PRODUCT CHANGE NOTIFICATION MAGNETICS •••

Bourns® Model SM91501AL BMS Transformer

Marking Appearance Change

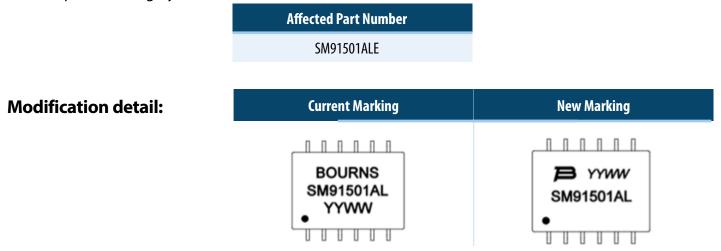
Riverside, California – June 28, 2021 – Effective September 27, 2021, Bourns will change the marking appearance and orderable part number of the Model SM91501AL BMS Transformer to establish consistency with the product category.

Current Orderable Part Number: SM91501ALE New Orderable Part Number: SM91501AL-E

The form of the model will change due to the modified marking format. The fit, function, guality and reliability will remain unchanged. Samples are available upon request.

Date that manufacturing of existing products will cease: September 27, 2021 Date that deliveries of modified products will begin: September 28, 2021 First date code using the above changes: 2139
